Review of Indian Point

On Thursday, March 9, I reviewed the eddy-current inspection at the Indian Point 2 power plant. The prior inspection, in 1997 had been done with probes and procedures designed to detect od defects, rather than the id defects that are present in the u-bends. In addition, the phase setting used by the utility, which is critical for id defect detection, was an old one specified for pancake probes, which is not adequate for the plus-point probe. The EPRI probe qualification for the plus-point used a correct setting in 1997 and uses the correct one at the present time. In reviewing the data, it was obvious that the phase setting was too low in 1997. This was one contributing factor to the indication being missed. The correct phase setting was already being used at this inspection when we visited the plant.

Figure 1 Impedance change due to the addition of a copper cladding on the tube at different frequencies.

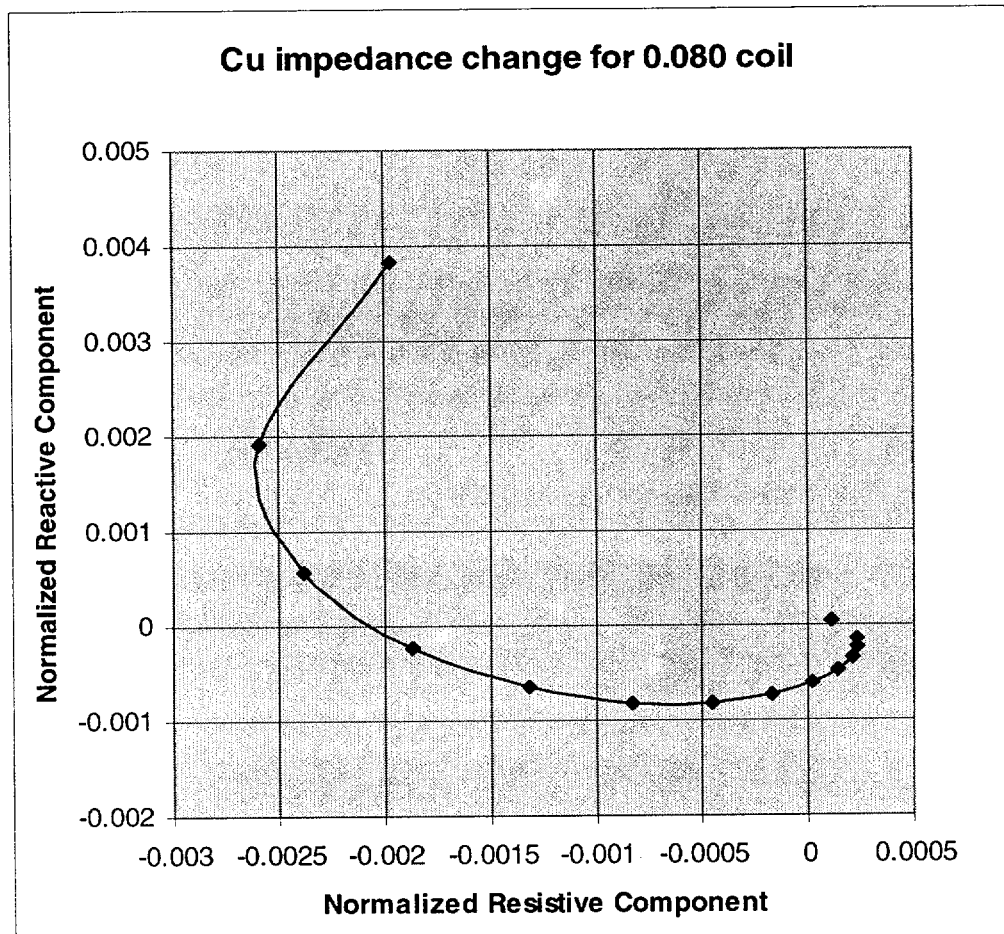
In Figure 1 the computed the normalized impedance change for a 0.080 pancake probe between no copper and an infinite thickness of copper on the outside of the Inconel tubing is shown. The frequency is increased form 300 kHz to 2 MHz in 100 kHz steps, with a jump from 1.5 MHz to 2 MHz for the last two steps. The amplitude of the impedance change at 1.0 MHz is 17.5% of that at 300 kHz, and the phase has been

shifted about 90 degrees. This “noise signal” does not give a straight vector from zero thickness to infinite thickness, but will produce a “fish-hook” shaped vector. Due to edge effects and other

Figure 2 Response of a 0.080-inch probe to notches, copper and lift-off at 300 kHz.

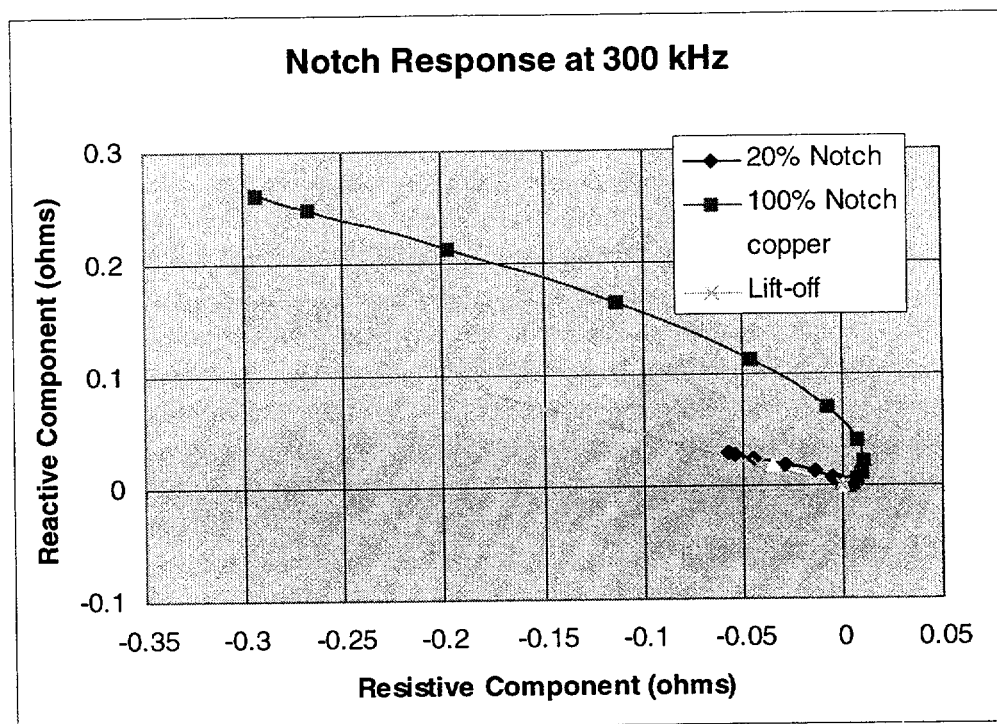
and shows how the phase can be adjusted to reduce the noise. The computations for the 100% notch have not converged properly yet, but they give an approximate reading of its effect. The computations of the copper and lift-off are very accurate. In Figure 2 we show the computations for the 0.080-

inch probe at 300 kHz. (The modeling has not been done for the plus-point probe, but the media effects will be somewhat similar.) Note that the phase orientation of the 20% notch, the copper coating and the lift-off signal all have about the same phase shift. ODSCC defect signals in the generator have amplitudes of about 10% of the notch amplitude, but the same phase. Therefore, as can clearly be seen, the defects are impossible to separate from the noise.

Figure 3 Response of the probe at 1 MHz.

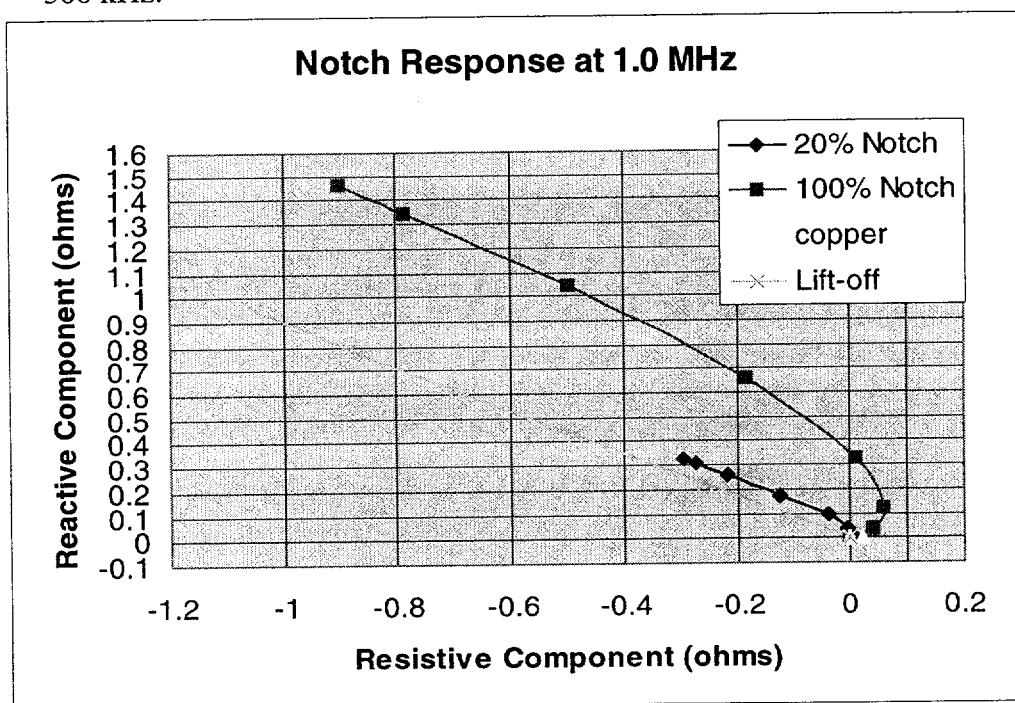
By contrast, at 1 MHz the phases and amplitudes are much more favorable. In Figure 3 we show similar plots made at the higher frequency. There is more separation of the 20% notch and the lift-off. Also, the copper signal has rotated around until it is almost horizontal. This considerably reduces the effects of the noise signals on the detection of the defects. There is more phase spread between the 20% and 100% notches, which allows a more accurate sizing.

Figure 4 Plot of 1997 scan of tube 2-72 of steam generator 24 made at 400 kHz made with midrange plus-point.

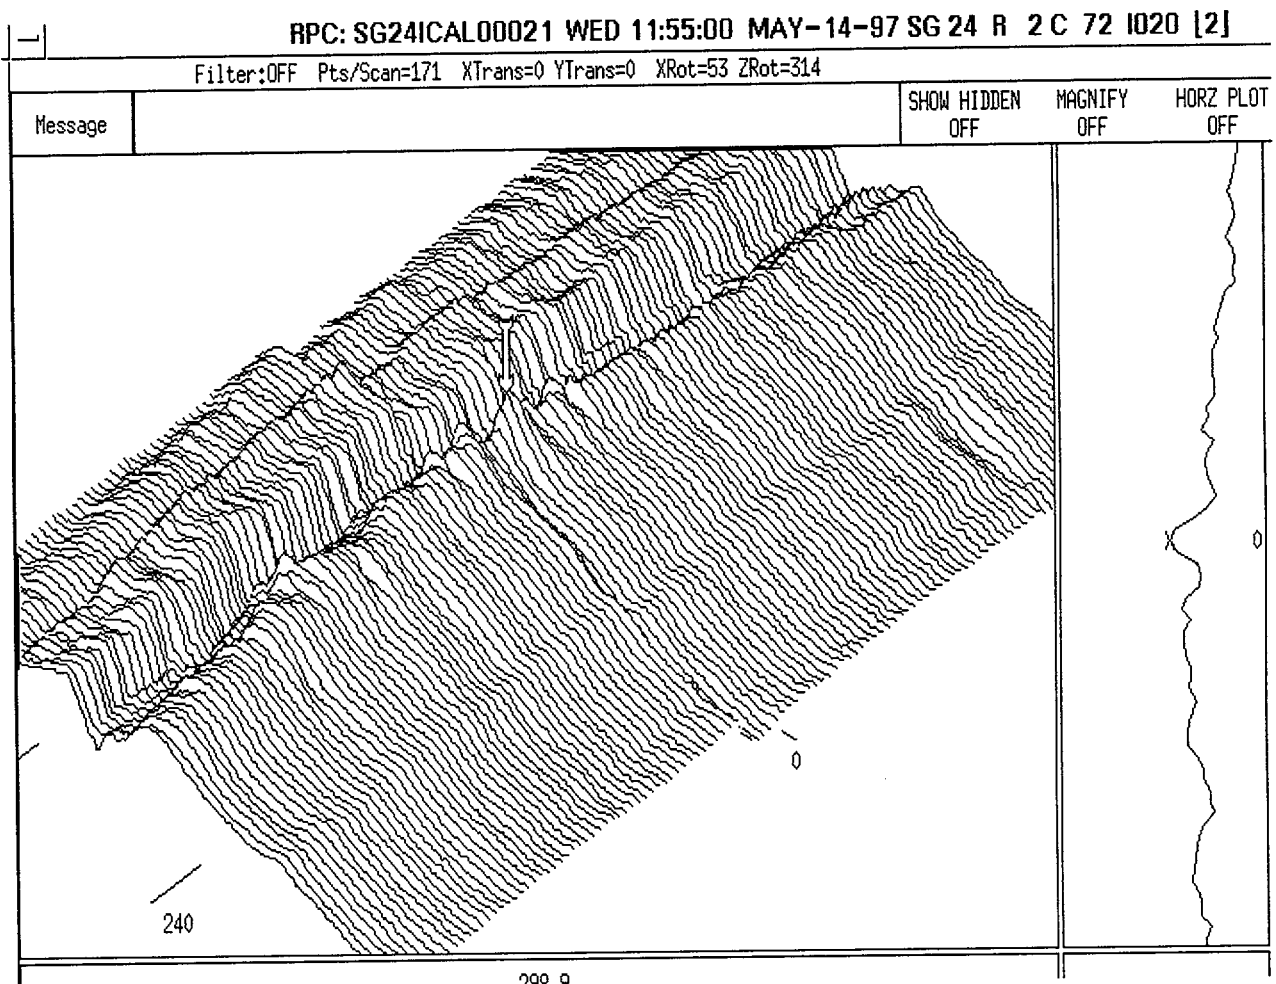
In Figure 4 we show a scan of the midrange plus-point, using the present phase setting. The indication is barely visible, and was not called in 1997. In figure 5 we show a scan of the same tube using the small, high-frequency plus-point, that has been calibrated in a similar manner. The improvement in the signal-to-noise ratio makes this defect very easy to detect. The reduction in noise will also allow more accurate profiling of the cracks. The signal-to-noise

Figure 5 Plot of the smaller, high-frequency plus-point probe at 800 kHz made at this outage. All voltage settings are calibrated at 20 volts on the 100% defect at each frequency.

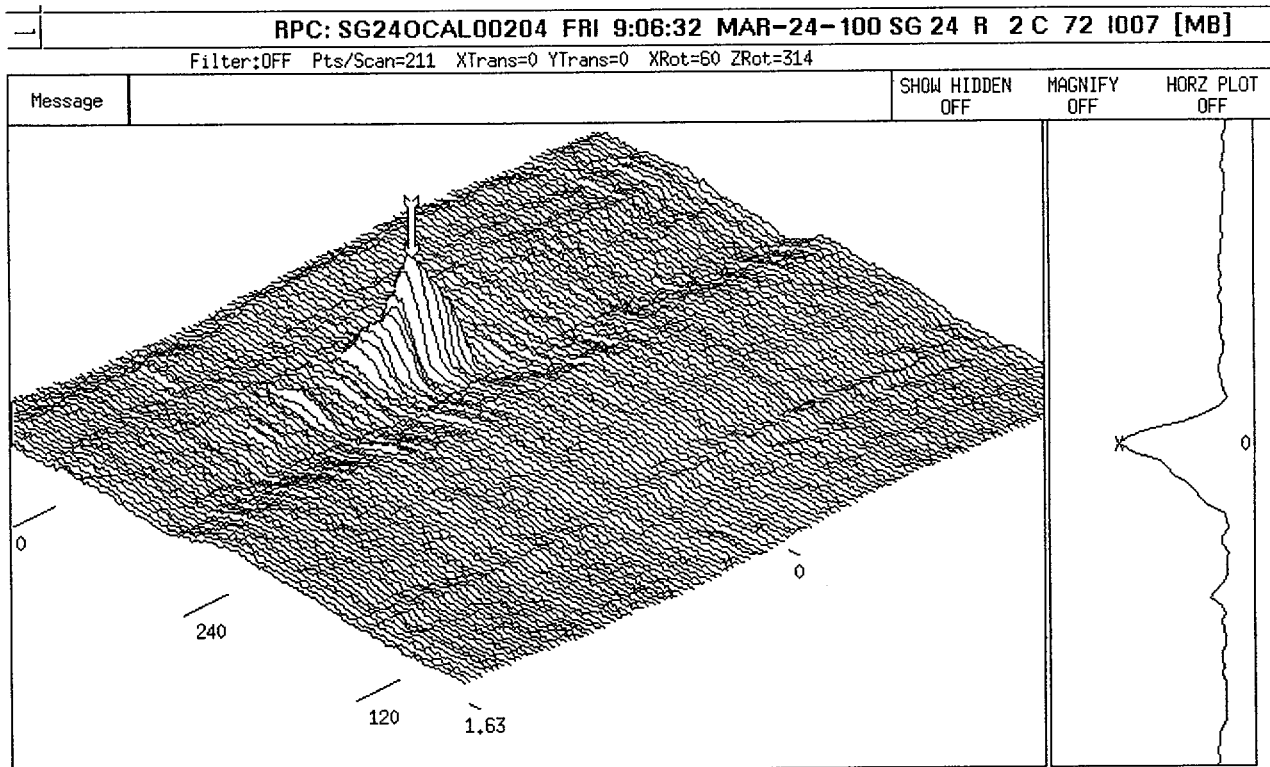
improvement is partially the result of the probe being made smaller also. The new probe has less noise at the 300 and 400 kHz frequencies than the old mid-range probe has.
